**DOWNTOWN LIGHTING AND PEDESTRIAN IMPROVEMENTS
PROJECT NO. 07-961-83-054**

ADDENDUM NO. 2

May 6, 2008

ADDENDUM 2 - SKETCH 1

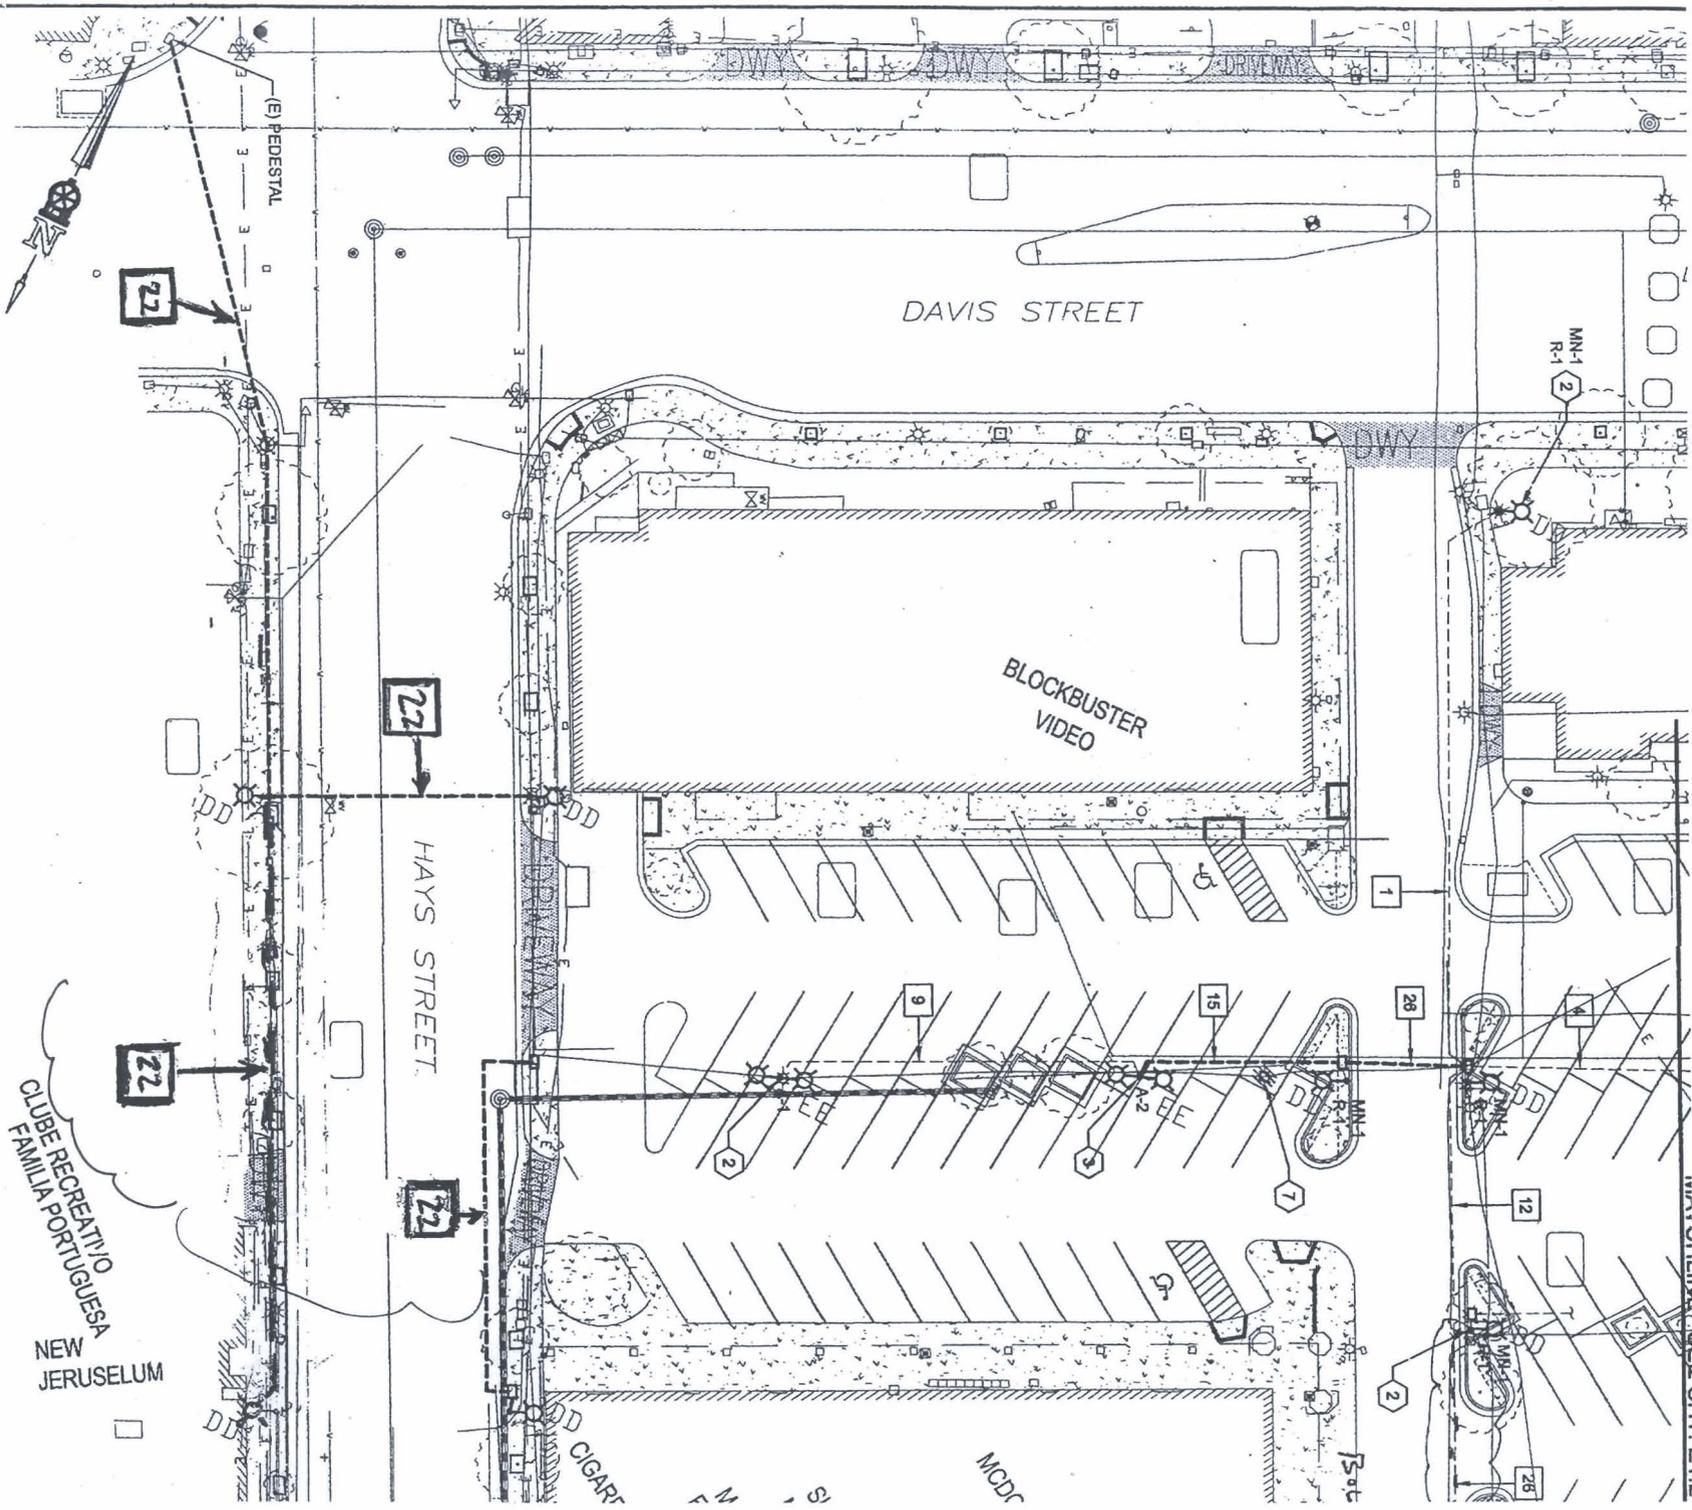
Drawing E1.0

- Added key notes indicating conduit and conductor sizes according to schedule on Sheet E0.3. (*See attached Sketch 1*)
